# MEMORANDUM

Re: PLNSUB2018-00033 Hopkins Estate Planned Development at 1950 & 1960 South 1700 East – requested final review of single-family home proposed for lot 1

**ACTION REQUIRED:** Consider and make a final decision on the proposed design of the single-family home to be constructed on lot 1, which has frontage on 1700 East.

Approved site plan with reduced front (green) and rear (blue) yard setbacks for lot 1.

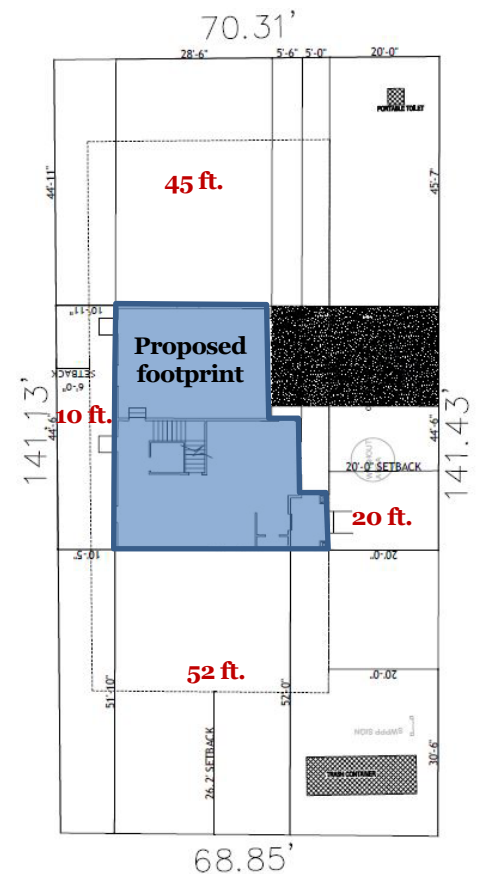
**PROPOSAL FOR LOT 1:** All of the new single-family homes could potentially have footprints that measure up to 3,000 sf (the approximate size of the approved building pads), but the home being proposed for lot 1 has a footprint of approximately 1,323 sf. This results in a smaller home with rear and south side yard setbacks that are larger than what is possible under the approved site plan:

<u>Approved</u>	<u>Proposed</u>
<b>Front Yard (East)</b>	20 ft.	20 ft.
<b>Interior Side Yard (North)</b>	45 ft. (includes drive width)	45 ft.
<b>Interior Side Yard (South)</b>	26 ft.	52 ft.
<b>Rear Yard (West)</b>	6 ft.	10 ft.

The home has been sited so that the north side façade is in line with the approved front yard setbacks for the homes to be built on lots 2 – 5. This ensures a consistent building setback along the new private driveway, and creates a larger south side setback area that the property owners can use as their yard space.

Front (east) elevation – faces 1700 East

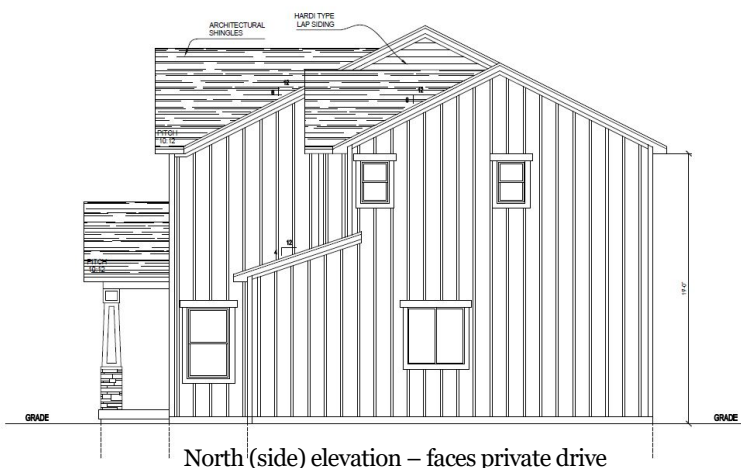
The home proposed for lot 1 has two (2) above-ground stories with an attached 2-car garage. The front façade is oriented toward 1700 East, and the vehicle access would be via driveway that stems from 1700 East, as shown in the approved site plan and preliminary subdivision plat. The structure would be 28 feet tall at its highest point. The primary building materials include a vertically-oriented board and batten siding made of Hardie board, a horizontally-oriented lap siding made of Hardie, shakes made of Hardie in some of the gable peaks, and a small amount of stone on the front porch columns. The Planning Division considers all of these to be durable, quality building materials that comply with the associated condition of approval.

In addition to the condition of approval related to durable building materials, Staff also finds that the proposed design complies with the other three (3) conditions applicable to lot 1, namely:

- East (front) elevation complies with 21A.24.010.I Front Façade Controls, which stipulates that at least 10% of the front elevation area shall be made of architectural features such as an entrance door, windows, balconies, porches, etc.
- East (front) elevation complies with 21A.24.060.H Standards for Attached Garages, which states that the width of the garage doors shall not exceed 50% of the width of the front façade, and the garage shall be located behind or in line with the front line of the building.
- The proposed structure complies with all other lot and bulk requirements found in 21A.24.060 R-1/7,000 Single-Family Residential District.

Proposed site plan—applicant is requesting reduced front (green) and rear (blue) yard setbacks for lot 1.

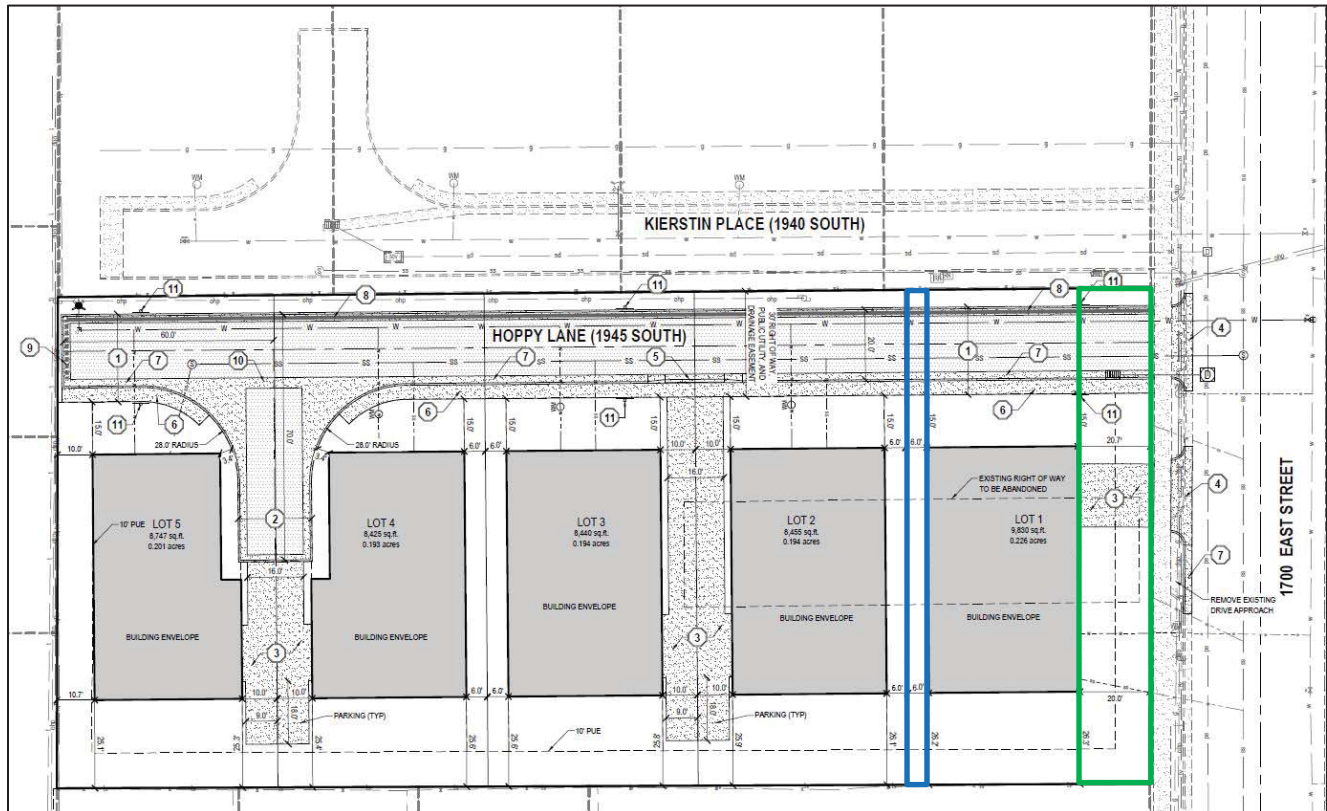
Lot 1 would have direct driveway/garage access off of 1700 East, but lots 2 & 3 and 4 & 5 would have shared driveways running between them that lead to garage entrances located toward the rear of the home. The shared driveways continue past the shown building envelopes, which would provide one spare parking space per lot, and could also be used as a turnaround area.

Planned Development approval is required for this project due to lots 2-5 not having frontage on a public street. In addition, the applicant is requesting reduced front and rear yard setbacks for the home on lot 1. Per code, *the minimum depth of the front yard for all principal buildings shall be equal to the average of the front yards of existing buildings within the block face*. Staff estimates that the average front yard depth along the block face is approximately 27 feet; the applicant is requesting 20 feet. In addition, the rear yard shall be a minimum of 25 feet, and the applicant is requesting 6 feet. Even though this seems like a large discrepancy, the rear yard of lot 1 functions more like an interior side yard, so Staff finds that the 6 foot setback is appropriate when the larger context is considered. Since the future homes on lots 2-5 would be oriented toward the proposed private driveway, the applicant has designated the north side of those lots the front yards, the south side of the lots the rear yards, with the remainder being interior side yards. Under those designations, the proposed envelopes on lots 2-5 have been designed to meet the minimum front, rear, and interior side yard setback requirements for the R-1/7,000 zone.

- The future home on Lot 1 will be accessed via driveway off of 1700 East. The site plan also shows an extra parking space contiguous with this driveway, but I don't believe that would be permitted in the front yard.

*During the building permit review process for homes built on lots 2-5, the plans will need to show that there is a minimum dimension of 22 feet, 7 inches between the garage entrances along the shared driveways. The applicant revised the plans to remove the extra parking space within the front yard on lot 1.*
